Re: Calpine Geysers Units 3, 16, 17, 18, 19, and 20 License Amendments

Calpine Geyser's Units 3, 16, 17, 18, 19, and 20 Amendments

Prepared for
Calpine

June 18, 2003

Figure 8

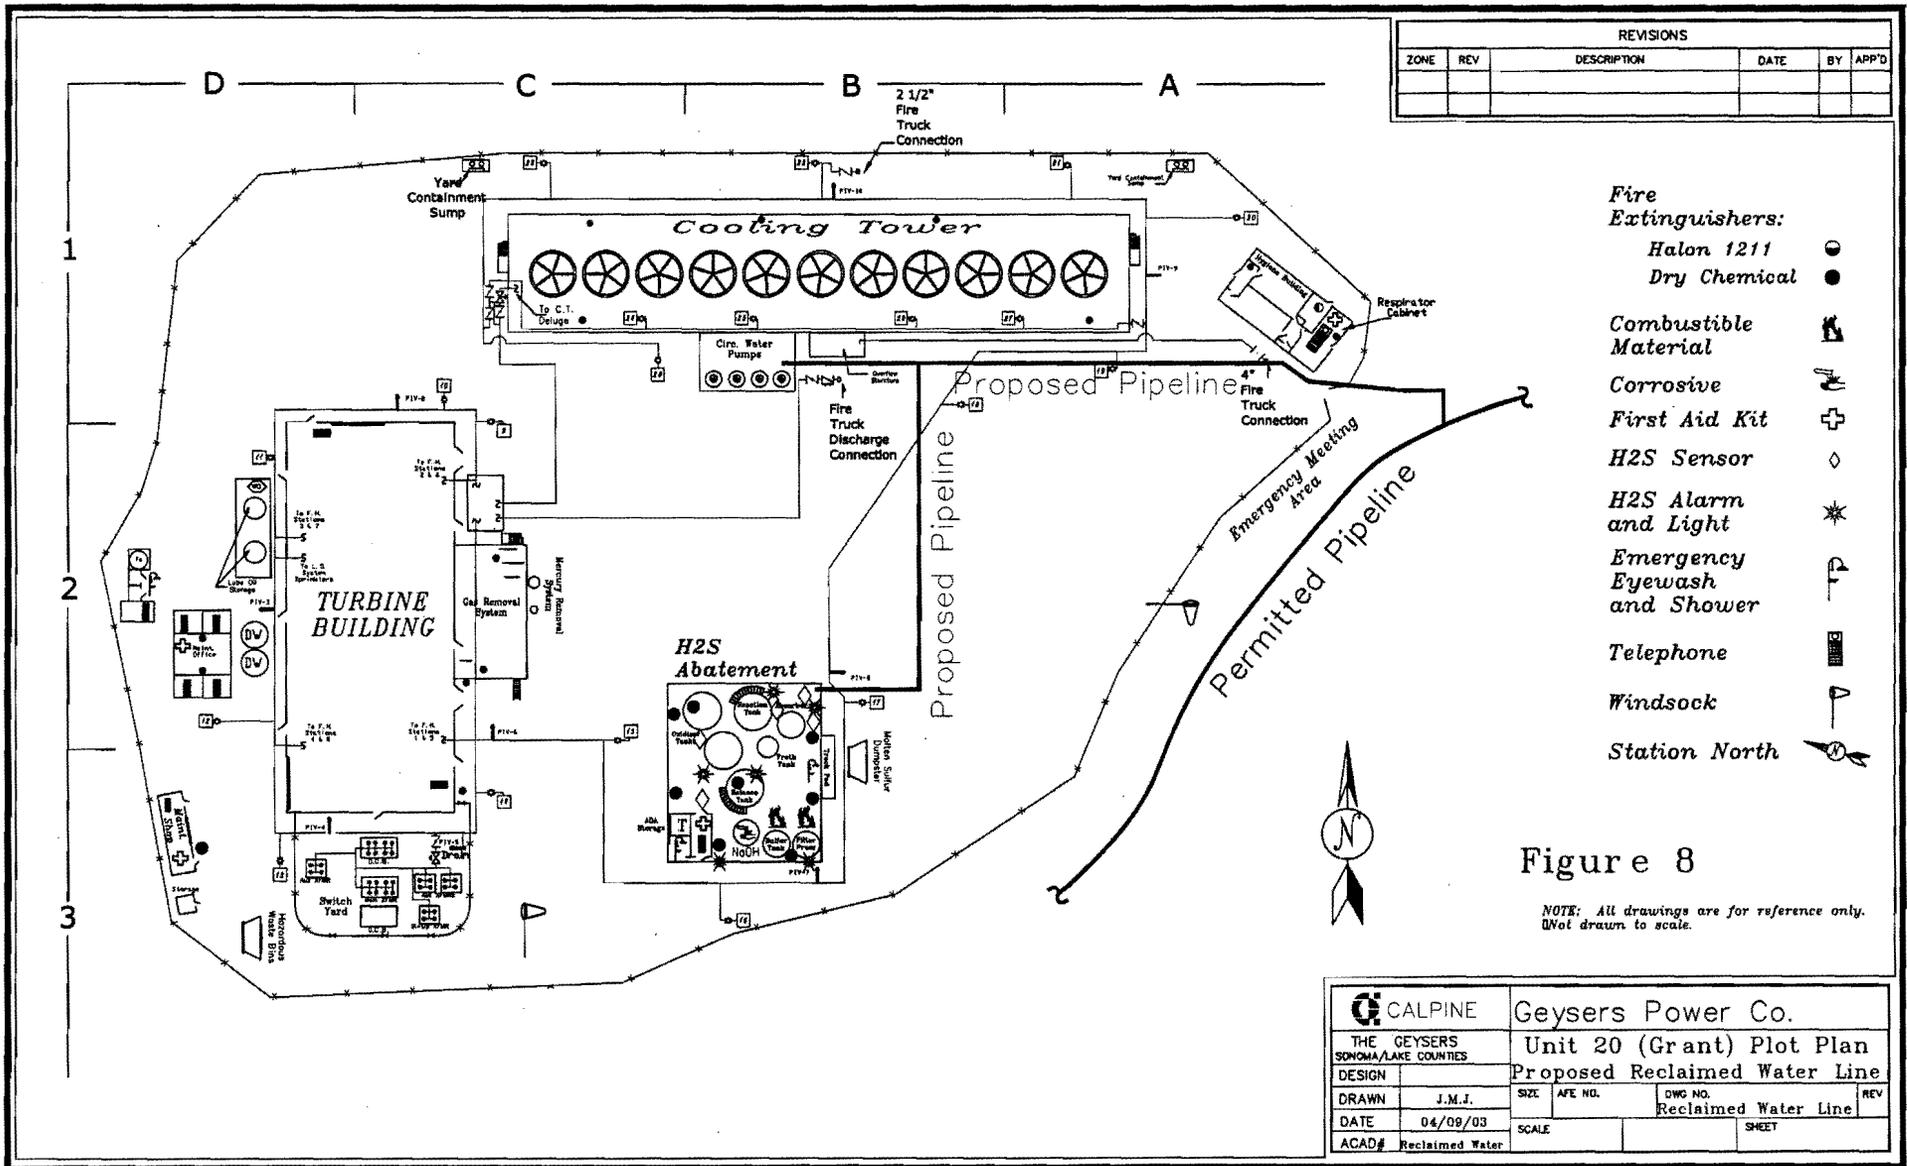
As shown in Figures 8 and 14, the existing recycled water supply pipeline is located in the access road adjacent to Unit 20. The proposed pipeline will interconnect to the existing supply pipeline by trenching in the access road at a depth of approximately 3 feet directly to the west end of the cooling tower, where the pipeline will daylight and be above grade. The soils that will be disturbed are in the road bed and the plant site, and are already highly disturbed due to the initial plant and road construction. Therefore, no cultural resource impacts are expected.
